**To:** Kristopher Byrd, Well Construction and Compliance Section Manager  
**From:** Joel Jeffery, Well Construction Program Coordinator  
**Subject:** Review of Water Right Application G-18612  
**Date:** August 7, 2018

Application # G- 18612

# Application G-18612, Arnold T5S, R2E - Section 14

Water-Level Trends in Nearby Well

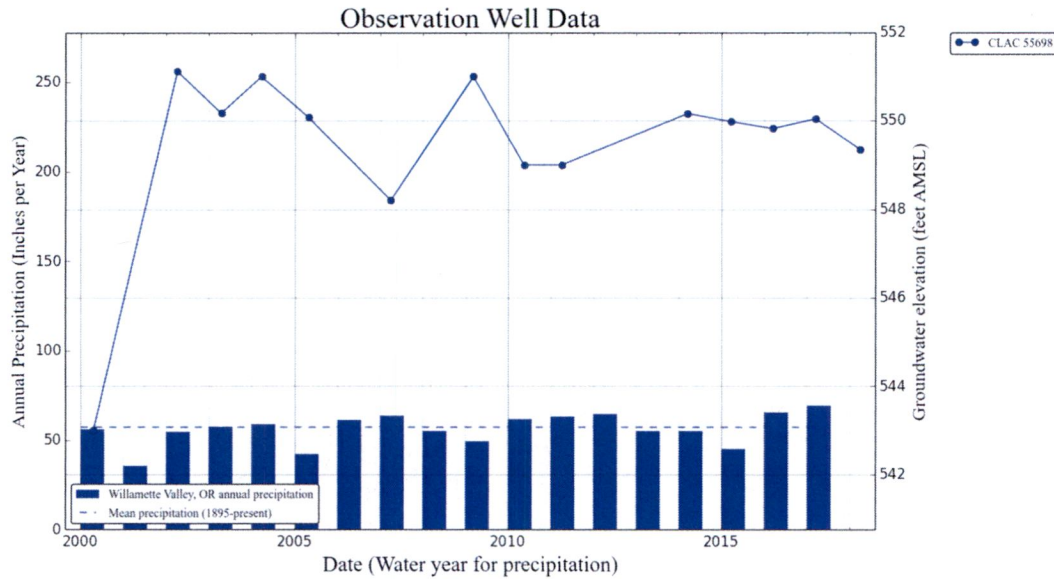
Large-scale groundwater use in this area is relatively low, with mostly domestic wells in the area, and thus available water-level data is also sparse. Data available from one nearby well, CLAC 55698, shows general stability over the past ~15 years, and particularly so in the past 4-5 years (see attached hydrograph).
